Case Number: BOA-23565

BOARD OF ADJUSTMENT CASE REPORT

<u>ACTION REQUESTED</u>: Variance to allow the floor area of detached accessory buildings to exceed 500 square feet and 40% of the floor area of the principal residential structure (Section 45.030-A, 45.031-D.6); Variance to allow a Detached Accessory Buildings to exceed one story or 18-feet in height and to exceed 10-feet in height to the top of the top plate in the rear setback (Section 90.090-C2).

Summary of Comments on SP1.0

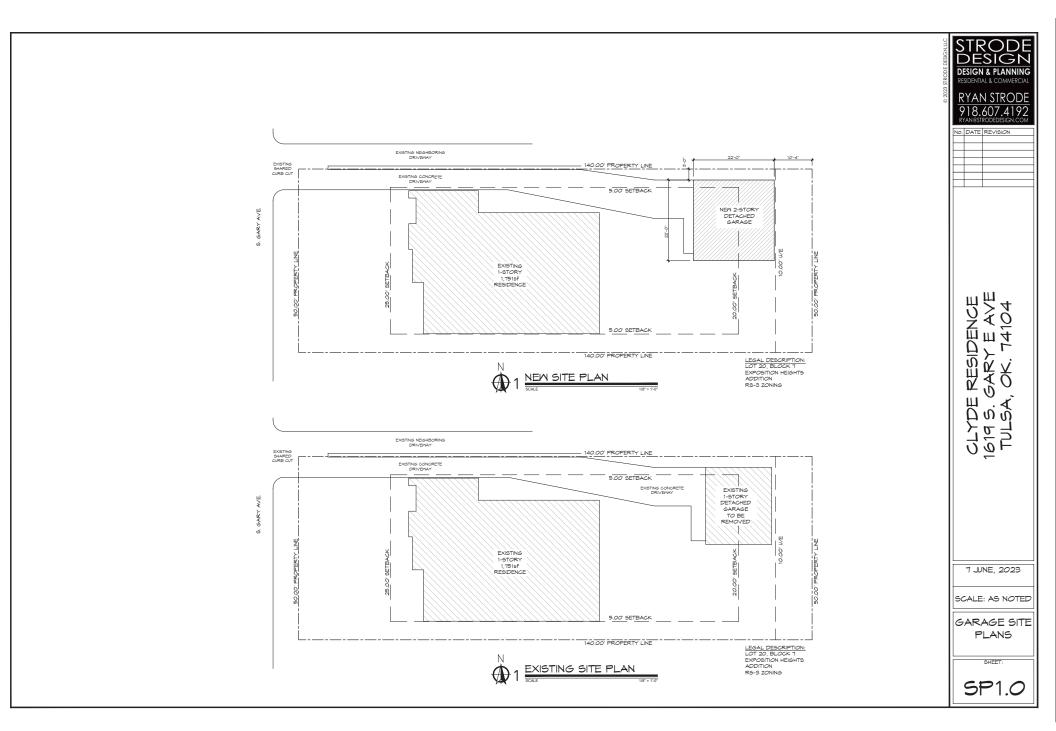
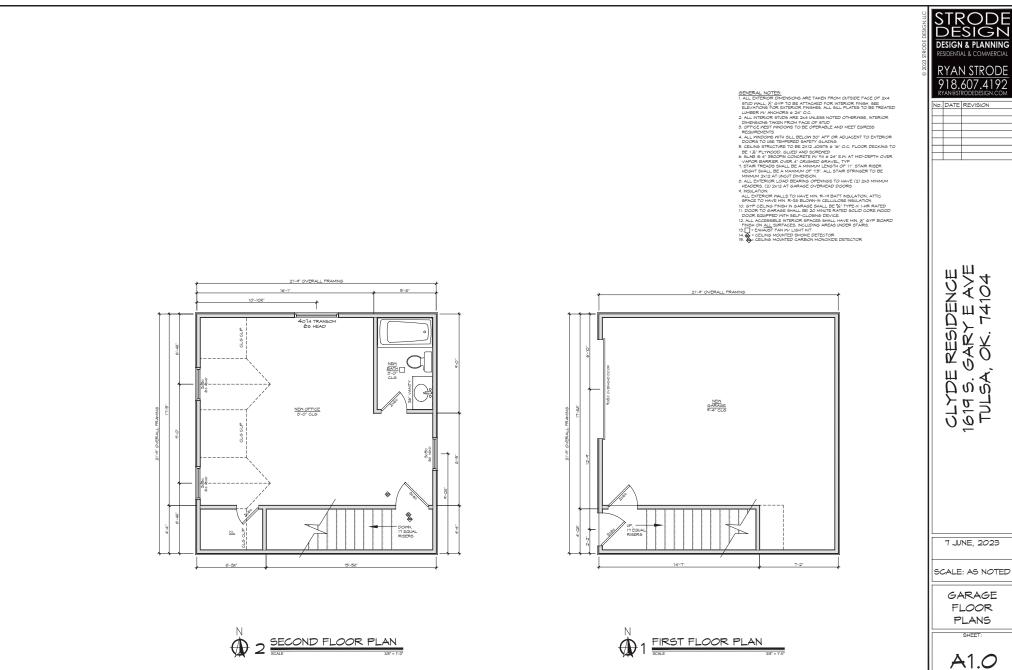
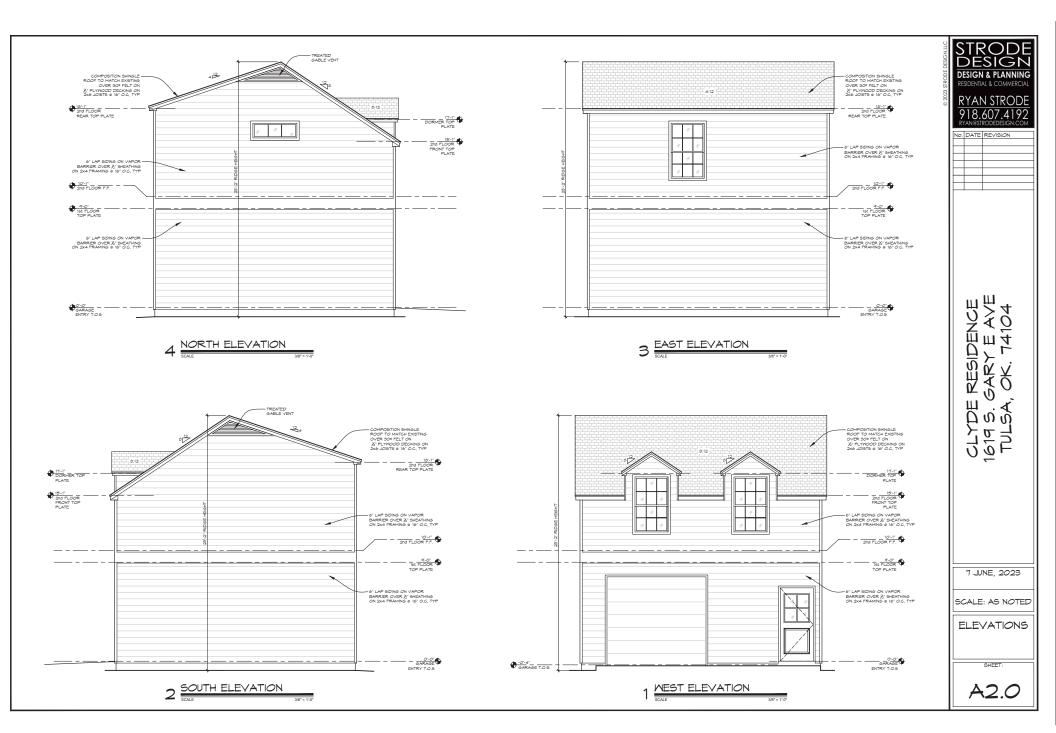
Page: [1] SP1.0 Author: James Henley Subject: WSD Comment Date: 6/20/2023 2:59:26 PM Number: 1 All developments shall be designed, constructed, and completed in a manner which minimizes the exposure of bare earth to precipitation. Revise site plan to show an Erosion Control Plan containing detailed location of all silt fence and other erosion and sedimentation control methods to be used during construction per City of Tulsa Standard 126. Number: 2 Author: DWhiteman Subject: Zoning Review Date: 7/10/2023 1:15:09 PM Note: this accessory building is not approved for or reviewed as an accessory dwelling unit. If this building is intended to be used as a dwelling unit, please request a special exception from the Board of Adjustment for an accessory dwelling unit located in an RS-3 zoned district. Number: 3 Author: James Henley Subject: WSD Comment Date: 6/20/2023 3:00:16 PM Revise site plan with drainage arrows that clearly identify how stormwater will flow around proposed construction and be conveyed to the street or public storm system. How does the construction change or affect drainage for the entire property? Number: 4 Author: DWhiteman Subject: Zoning Review Date: 7/10/2023 1:17:13 PM Section 90.090.C.2.a.1: Detached Accessory Buildings. Detached accessory buildings may be located in rear setbacks in RE, RS and RD districts, provided that the building does not exceed one story or 18 feet in height and is not more than 10 feet in height to the top of the top plate. Review Comment: The proposed building is located in the rear setback and exceeds 18' in overall height, 10' to the top of the top plate, and is two stories tall. Date: 7/10/2023 1:29:48 PM Number: 5 Author: DWhiteman Subject: Zoning Review The second floor of the proposed building is labeled office. How will the space be used? Will there be employees, customers, or clients coming to the site? Author: DWhiteman Date: 7/10/2023 1:25:24 PM

Section 45.030-B, RS-2, RS-3, RS-4, RS-5 an RM Districts. In RS-2, RS-3, RS-4, RS-5 or RM zoned lots used for detached houses or duplexes, the total aggregate floor area of all detached accessory buildings, including accessory dwelling units, and accessory buildings not erected as an integral part of the principal residential building may not exceed 500 square feet or 40% of the floor area of the principal residential structure, whichever is greater.

Review Comment: You are proposing 946 square feet of detached accessory structure floor area. The proposed detached structure exceeds 500 square feet and 40% of the size of the house. Based on the size of the house (1,751 square feet) you are allowed 700 square feet of detached accessory structure floor area on this lot. Please reduce the floor area of the proposed detached accessory structure to be 700 square feet or less.
